Docket Item # 7
BAR CASE # 2009-0117

BAR Meeting
July 29, 2009

ISSUE: Alterations
APPLICANT: Valda Anderson
LOCATION: 123 South West Street
ZONE: CL / Commercial

Figure 1. Photograph of front elevation

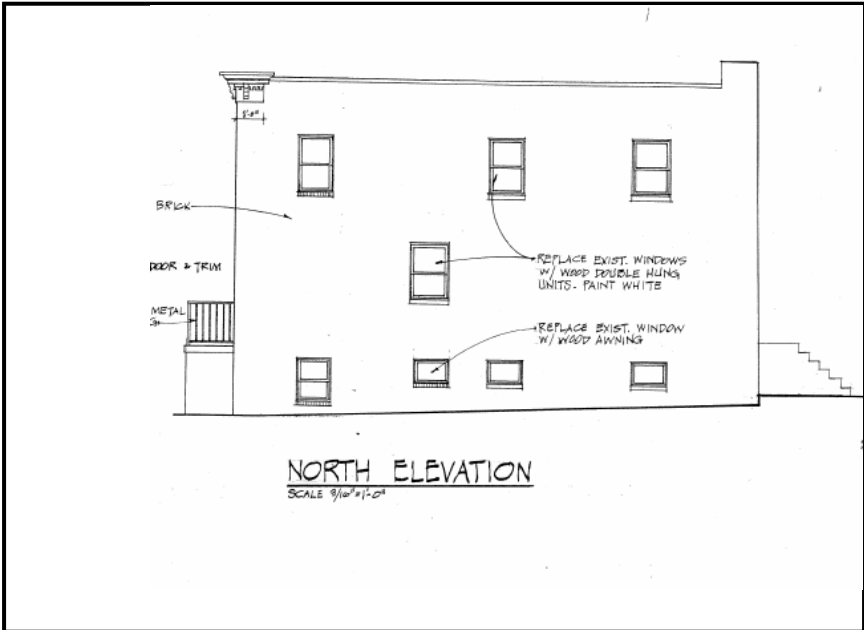
123 South West Street was designed and built with a minimalist aesthetic and is an example of the Modernist style in the Old and Historic Alexandria District. The house at 123 South West Street is similar in design to those designed by Joseph Saunders found on Gibbon Street, constructed in the 1950s. 123 South West Street and the houses on Gibbon Street are good examples of modernist architecture in the historic district that reflect the modernist architectural tradition in the United States and include such elements as proportional geometry, an absence of decorative ornament, the abstraction of design elements and factory metal casement windows. It is a rarity to find a building of this style and age in the district that maintains all of its original metal casement windows.

123 South West Street is a unique resource to the historic district in that it remains authentic to its original modern design without modification. Altering the facade by replacing the windows would greatly compromise the building’s historic integrity. It is

the opinion of Staff that the applicant did not follow through on the direction of the Board in restudying the windows or contacting a metal window restoration specialist. The applicant has not taken the instructed strides in providing documentation that the windows are in a state of disrepair requiring wholesale replacement. Furthermore, a replica wood casement window is an inauthentic representation of a character defining element of the building. Therefore Staff recommends denial of the application.

IV. STAFF RECOMMENDATION: Staff recommends denial of the application.

Figure 3. Proposed West Street elevation.

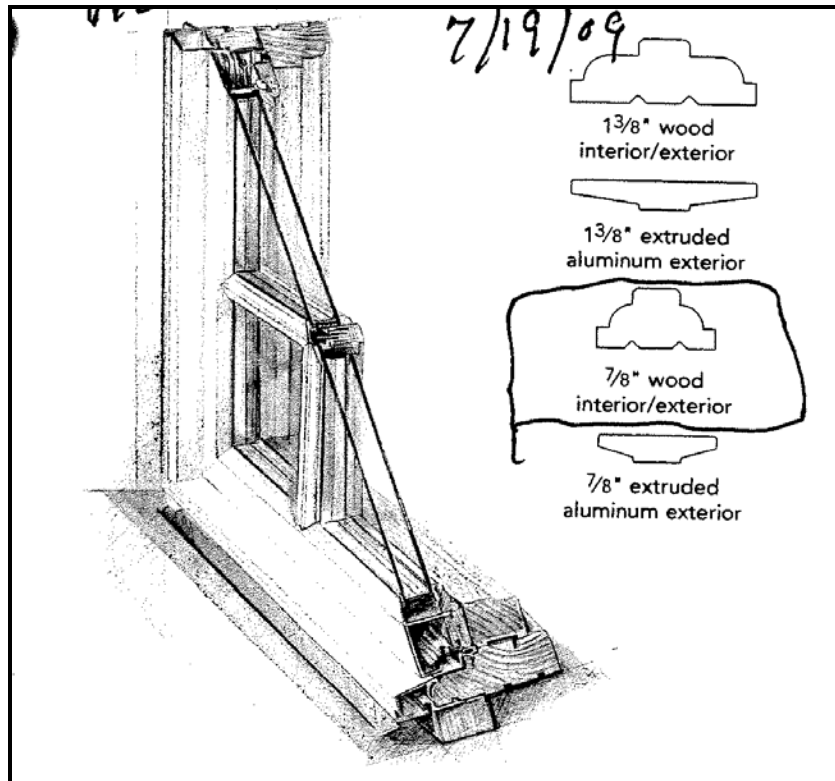
Staff received a revised submission depicting an identical application with the exception of changing the proposed windows on the South West Street elevation from double hung to casement windows in the same lite pattern as the existing windows.

The applicant is requesting a Certificate of Appropriateness for alterations at 123 South West Street. On the front façade the applicant is proposing the replacement of three metal casement windows and one metal awning window. The applicant has selected casement windows in identical lite patterns to the existing windows for all three original metal casement windows and a wood awning window to replace the original metal awning windows. The proposed replacement casement windows are Weathershield double-glazed, true divided light wood windows. The muntin profile will be 7/8 inch. On the north elevation the applicant is proposing the replacement of five metal casement windows and three basement level metal awning windows. The applicant has selected wood, double hung replacement windows for all five original metal casement windows, and wood awning windows to replace all three original metal awning windows. The proposed double hung replacement windows are one-over-one, double-glazed wood windows.
